Access Compliance Report

Public Rights-of-Way

(Curb Ramps)

Intersection ID: 10020593	Main Street: BASIE_PARK_CT	Cross Street: N/A	Location: SE
ADA ID: C46577637BD7	Ramp Type: Perp	Initial Pass/Fail: Fail	Overall Compliance: No
		Severity Score: 10

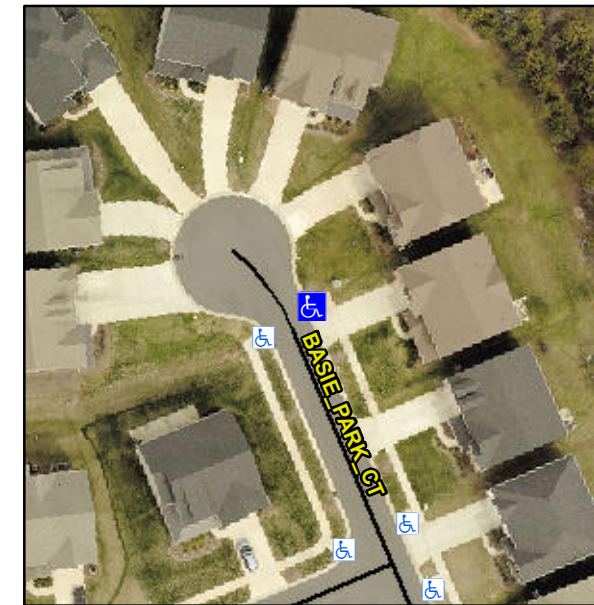
Not Found, R304.5.1, R304.5.3

Compliance	Description	Data	Compliance	Description	Data
N/A	Ramp Length (in)	92.0	Yes	Ramp Slope (%)	6.7
No	Ramp Width (in)	46.0	No	Ramp XSlope (%)	4.3
N/A	Flare Type LT	N/A	N/A	Flare Type RT	N/A
N/A	Flare Slope LT (%)	N/A	N/A	Flare Slope RT (%)	N/A
N/A	Flare Traversable LT?	N/A	N/A	Flare Traversable RT?	N/A
N/A	Landing Length (in)	N/A	N/A	DWS Provided?	N/A
N/A	Landing Width (in)	N/A	N/A	DWS Contrast?	N/A
N/A	Landing Slope (%)	N/A	N/A	DWS Length (in)	N/A
N/A	Landing X Slope (%)	N/A	N/A	DWS Full Width?	N/A
N/A	Landing Curb? (Y/N)	N/A	N/A	DWS Offset (in)	N/A
N/A	Shared Landing?	N/A			
N/A	Gutter Ponding?	N/A	N/A	Gutter Slope (%)	N/A
N/A	Gutter Lip Ht (in)	N/A	N/A	Gutter X Slope (%)	N/A
N/A	Painted X Walk1?	No	N/A	Painted X Walk2?	N/A
	X Walk 1 Direction	To W		X Walk 2 Direction	N/A
N/A	X Walk 1 Width (in)	N/A	N/A	X Walk 2 Width (in)	N/A
	X Walk 1 Slope (%)	3.7		X Walk 2 Slope (%)	N/A
	X Walk 1 X Slope (%)	3.2		X Walk 2 X Slope (%)	N/A

Remove & Replace Entire Ramp.
